SB-10055240-4338

Title: Prostar upper radiator pipe cracking or breaking at support bracket or at flange area

Applies To: Prostars built before 8/28/07

Drawing 1

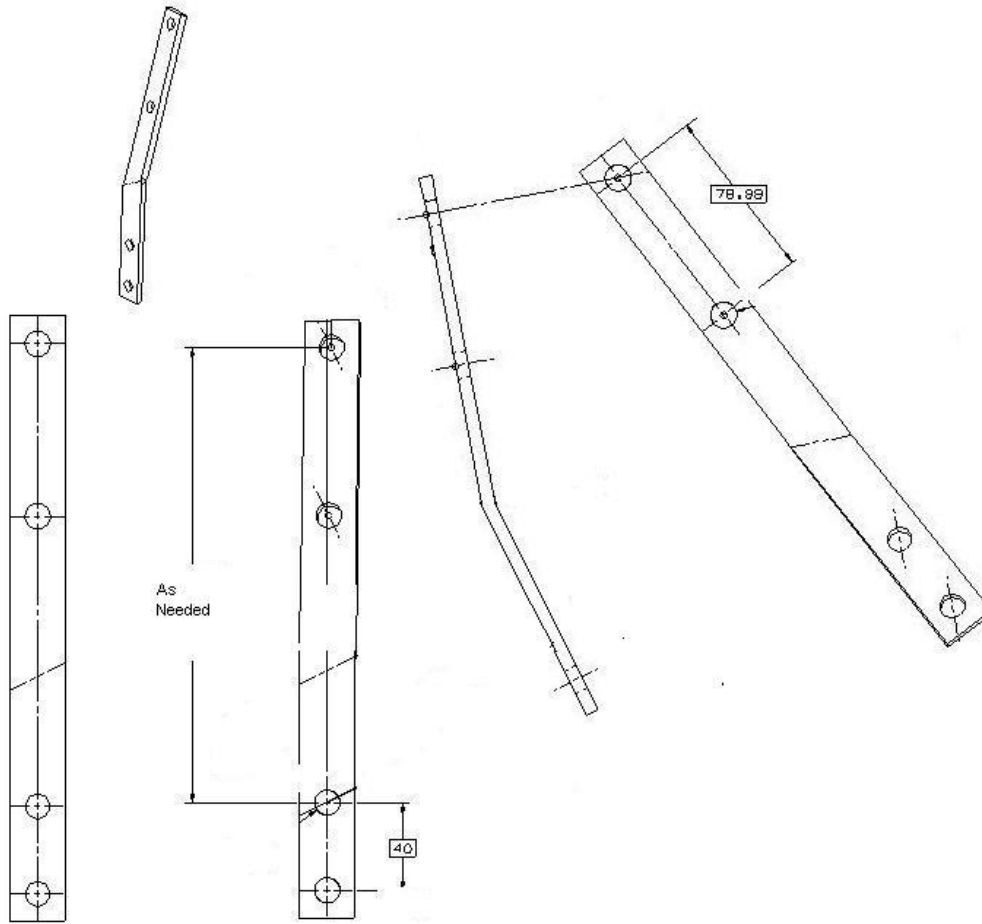
On some ProStar tucks built before 8/28/07 we have seen the upper radiator pipe break either at the support bracket that is welded to the pipe, or at the flange that mates to the engine. The fix is to cut off the support bracket that is welded to the pipe and make a simple bracket out of flat stock similar to drawing 1 below. Bolt the new bracket to the engine and secure the pipe to the bracket with an exhaust u-bolt (471200C1). Make sure to loosen the flange bolts and retighten them after all parts and hoses are loose-fit together and the pipe is secured to the bracket to prevent stress on the support bracket or flange.

Note1: In the near future you will be able to order Kit number 8000893R91 along with New pipe number 3625914C2. This kit will contain the new support bracket, U-bolt, nuts, and washers necesseccary to install the new pipe. Keep in mind that the new support bracket will not look like the bracket pictured below.
